Work Description
Techalloy Inc., Central Wire, Union, IL
November 18, 2014

From: Kay, Robert [rtkay@usgs.gov]
Sent: Monday, June 10, 2013 1:11 PM
To: Nordine, John
Subject: Re: FW: Electronic Files of Central Wire May 10 RCERA Corrective Action Implementation submittal to U.S.EPA

Response to Autumnwood REvised Response to USEPA review comments, 12-18-12.

Plot Title: iW-1

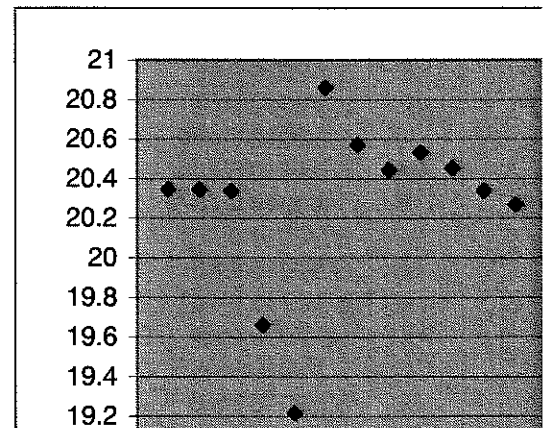
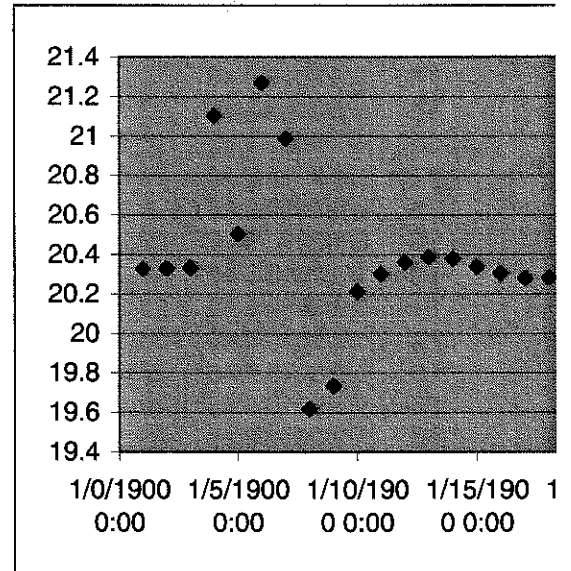
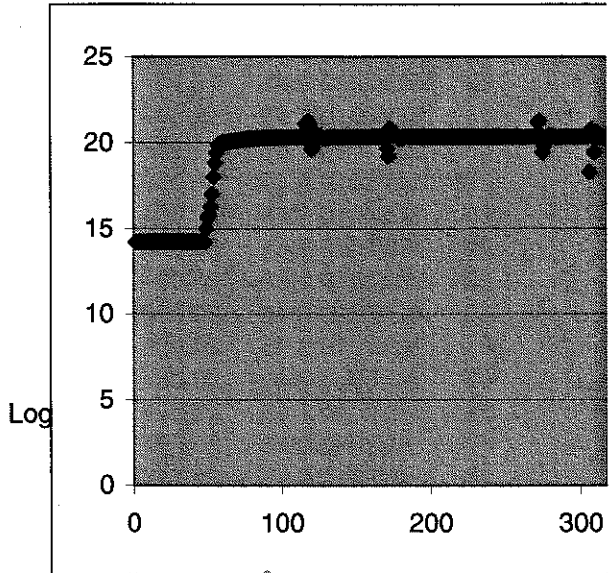
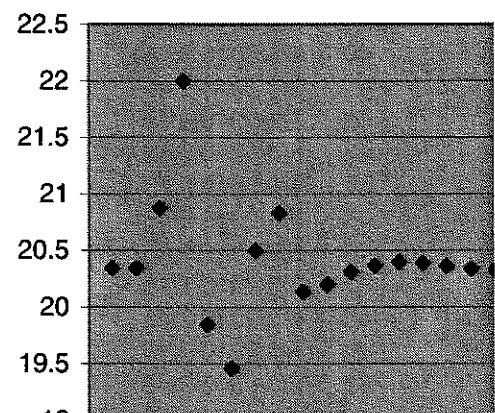
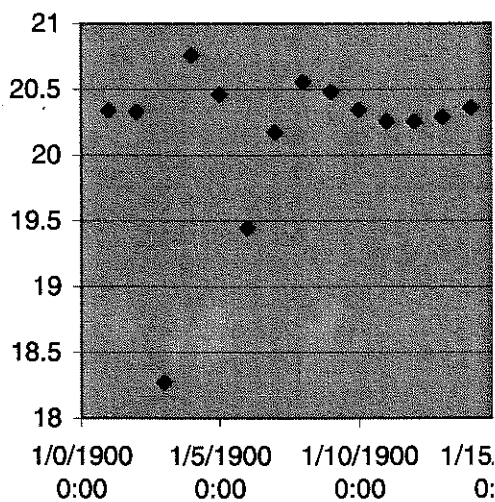
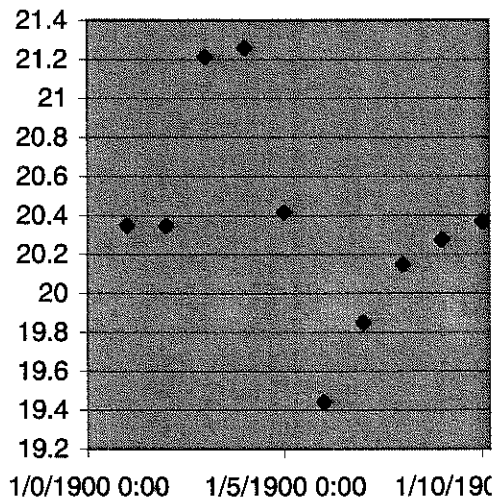
Jack and Steve--this is an oscillatory response. I'm not sure what kind of slug-test analysis package you have but it should have an oscillatory response solution--I usually use van der Kamp, but there are others. the attachment below is a re-work of the data and has some graphs of water levels at what I think are the times when the slug was inserted/removed. from this data you can calculate aquifer properties. however, there are a couple problems with the data.
